Department of Environmental Quality
Division of Radiation Control

May 23, 2003

SUBJECT: Response to DOE May 13, 2003 Letter Regarding Final Site Observational Work Plan for the Green River, Utah UMTRA Site

Pressure Head Map of Cedar Mountain Middle Sandstone Unit Green River UMTRA Site

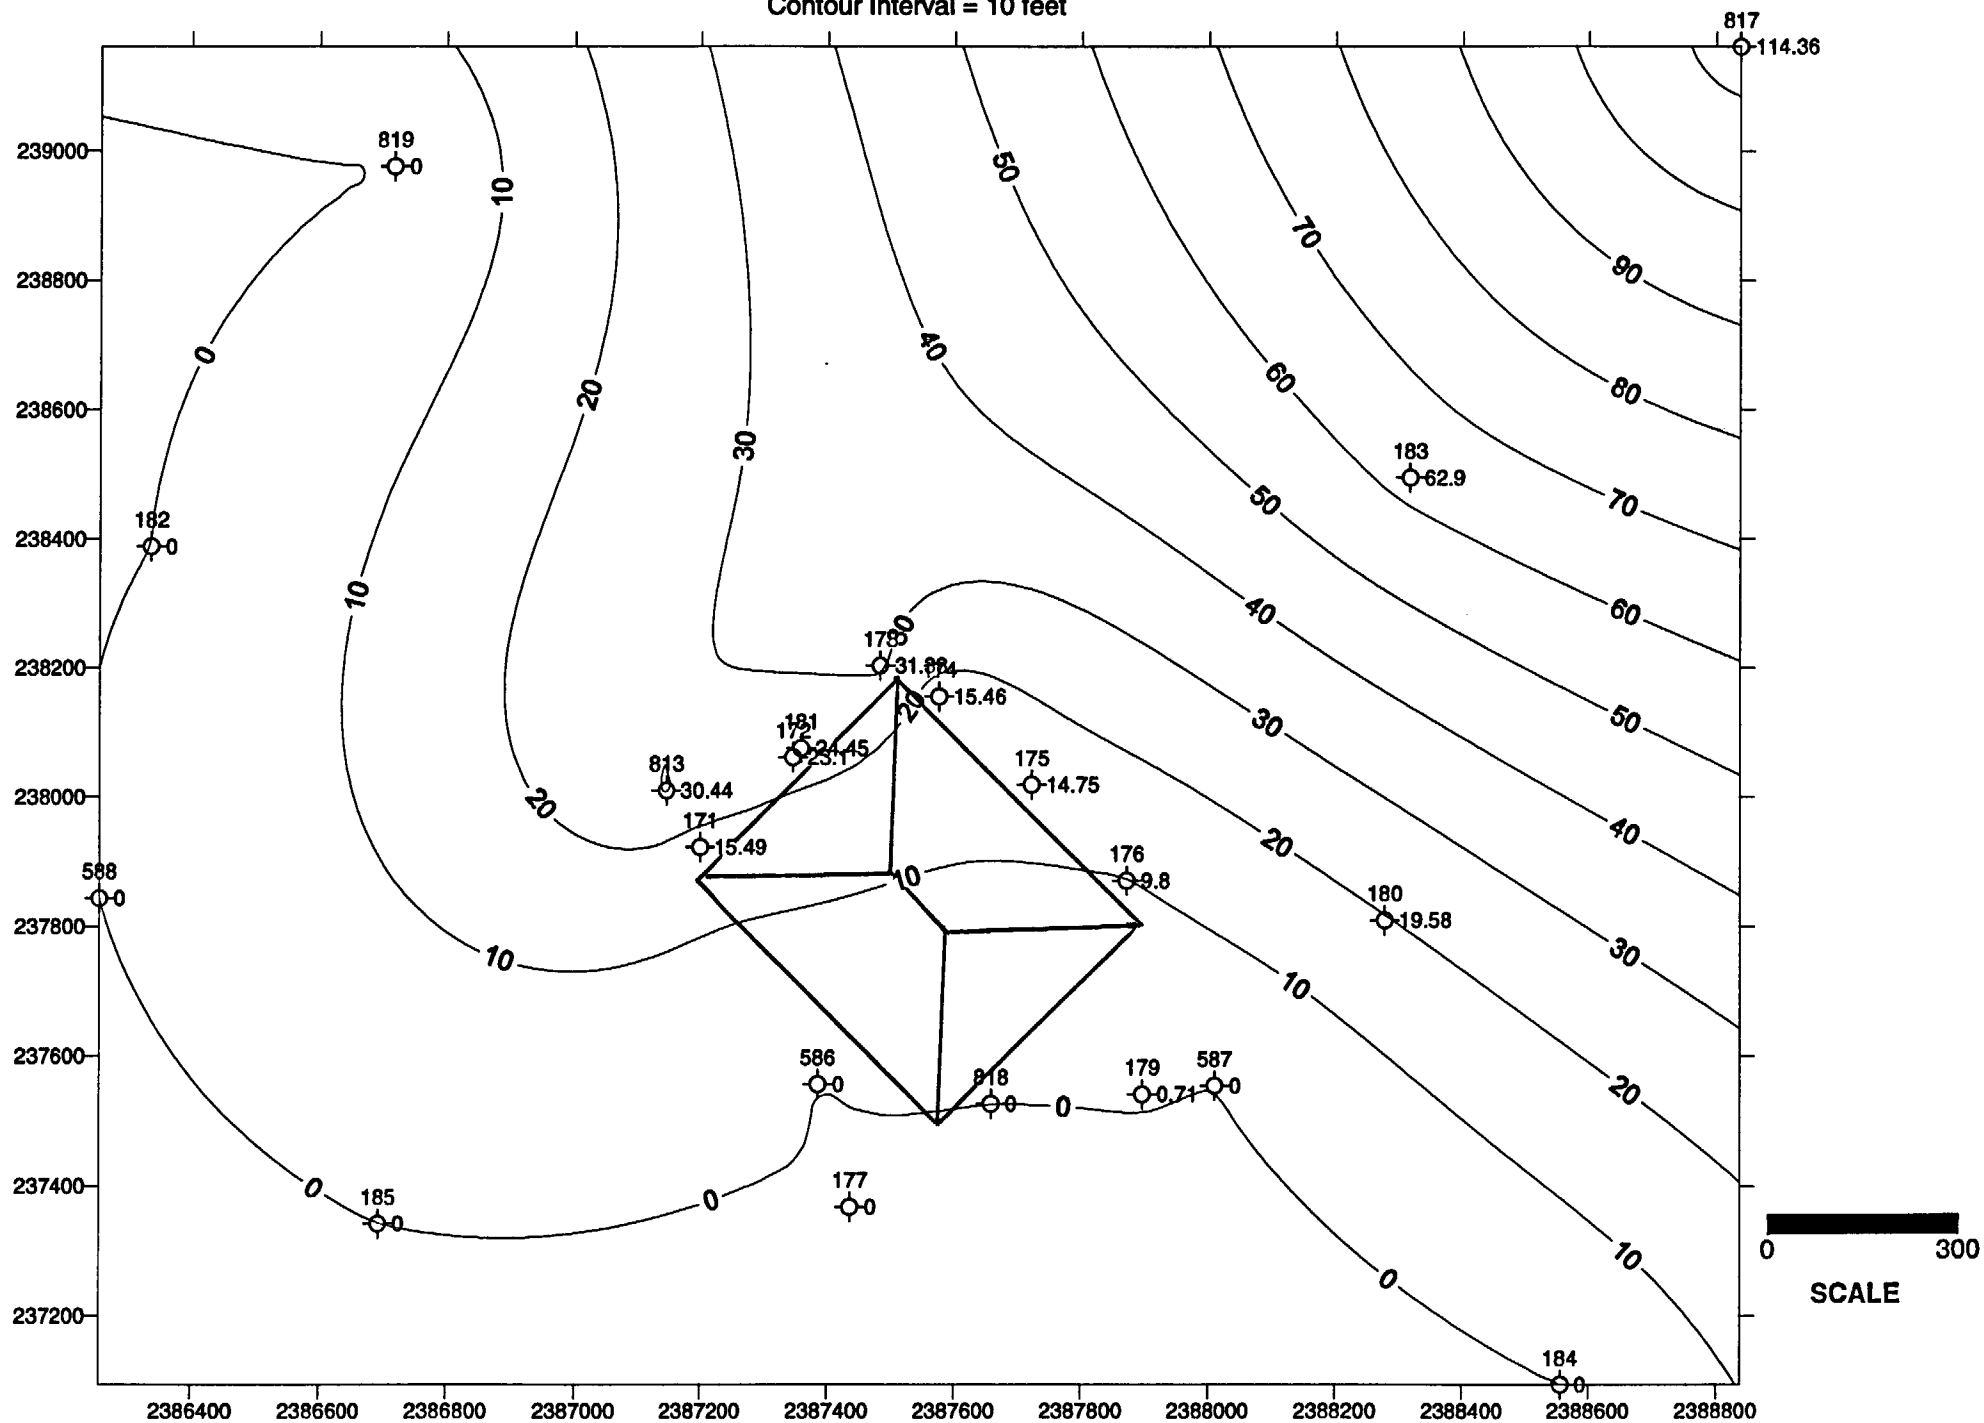
Pressure Head Map. As shown by the pressure head map in Attachment 1, the middle sandstone unit of the Cedar Mountain Formation is unsaturated or not present south and west of the disposal cell with increasing pressure head to the north and east. This indicates that no-flow boundaries exist in the Cedar Mountain middle sandstone unit west and south of the disposal cell. The underlying Brushy Basin Shale Member of the Morrison Formation forms a no-flow boundary for the overlying Cretaceous sandstone aquifers due to its bentonite content and extremely low permeability.

The vertical no-flow boundary of the Brushy Basin Member coupled with the horizontal no-flow boundaries in the Cedar Mountain Middle Sandstone aquifer west and south of the cell indicate a northward ground water flow direction towards Browns Wash.

Figure 5-6. Orientation of Fracturing and Joints at the Green River Site

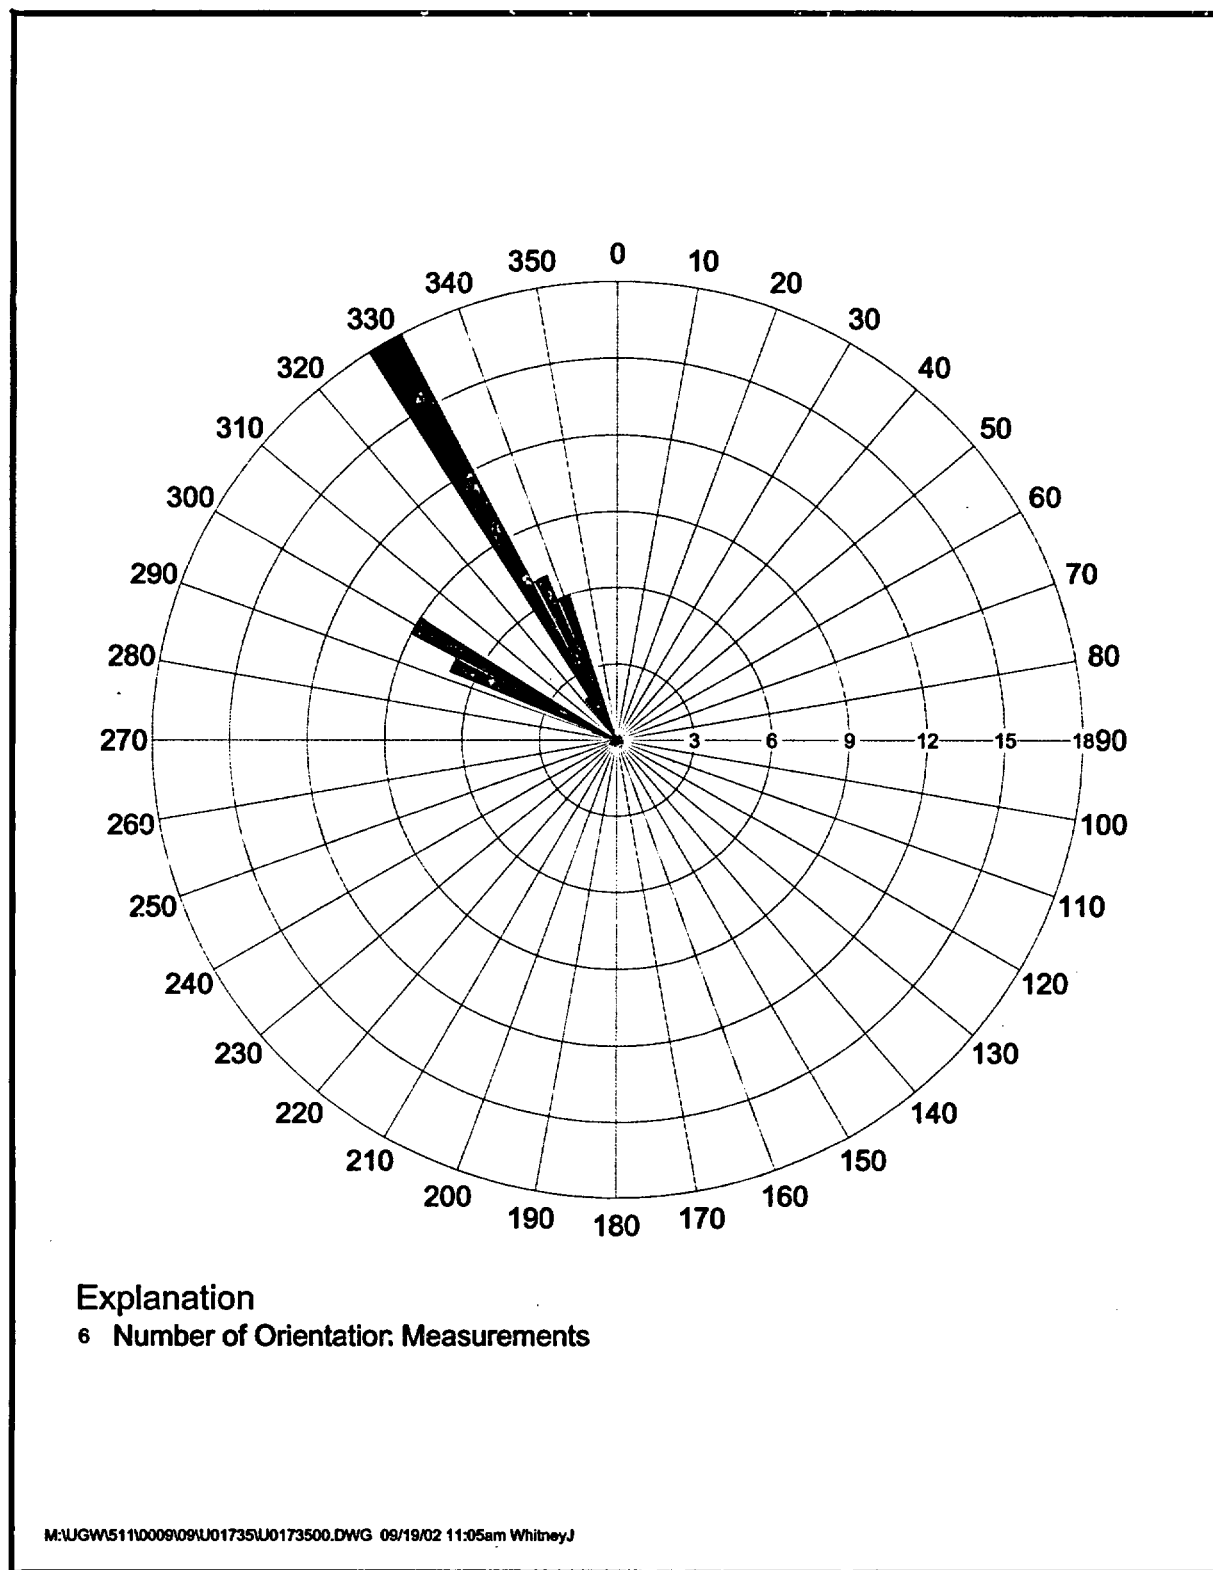
Fractures Patterns and Structural Dip. As indicated in Figure 5-6 of the Final SOWP, fracture and joint patterns have a predominant northwest orientation (Attachment 2). In addition, a structure contour map for the top of the middle sandstone unit indicates a northern structural gradient with a slight northwest dip component in the vicinity of the disposal cell (Attachment 3).
